# Access Compliance Report

### (Curb Ramps)

Intersection ID: 49931	Main Street: WOBURN_RD	Cross Street: ASHBOURNE_HALL_RD	Location: SE
ADA ID: 6E69F0D9AE0B	Ramp Type: Perp	Initial Pass/Fail: Fail	Overall Compliance: No
Severity Score: 13.75			
Codes/Mitigation Info/Possible Solution		Field Measurements/Component Compliance

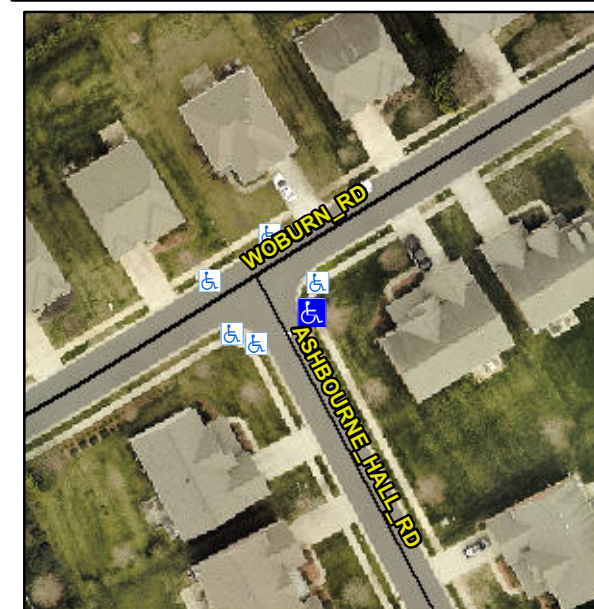
**Not Found, R304.2.2, R304.5.3**

Compliance	Description	Data	Compliance	Description	Data
N/A	Ramp Length (in)	50.0	No	Ramp Slope (%)	9.3
Yes	Ramp Width (in)	48.0	No	Ramp XSlope (%)	2.2
N/A	Flare Type LT	N/A	N/A	Flare Type RT	N/A
N/A	Flare Slope LT (%)	N/A	N/A	Flare Slope RT (%)	N/A
N/A	Flare Traversable LT?	N/A	N/A	Flare Traversable RT?	N/A
N/A	Landing Length (in)	N/A	N/A	DWS Provided?	N/A
N/A	Landing Width (in)	N/A	N/A	DWS Contrast?	N/A
N/A	Landing Slope (%)	N/A	N/A	DWS Length (in)	N/A
N/A	Landing X Slope (%)	N/A	N/A	DWS Full Width?	N/A
N/A	Landing Curb? (Y/N)	N/A	N/A	DWS Offset (in)	N/A
N/A	Shared Landing?	N/A			
N/A	Gutter Ponding?	N/A	N/A	Gutter Slope (%)	N/A
N/A	Gutter Lip Ht (in)	N/A	N/A	Gutter X Slope (%)	N/A
N/A	Painted X Walk1?	No	N/A	Painted X Walk2?	N/A
	X Walk 1 Direction	To SW		X Walk 2 Direction	N/A
N/A	X Walk 1 Width (in)	N/A	N/A	X Walk 2 Width (in)	N/A
	X Walk 1 Slope (%)	2.9		X Walk 2 Slope (%)	N/A
	X Walk 1 X Slope (%)	0.5		X Walk 2 X Slope (%)	N/A

**Remove & Replace Entire Ramp.**
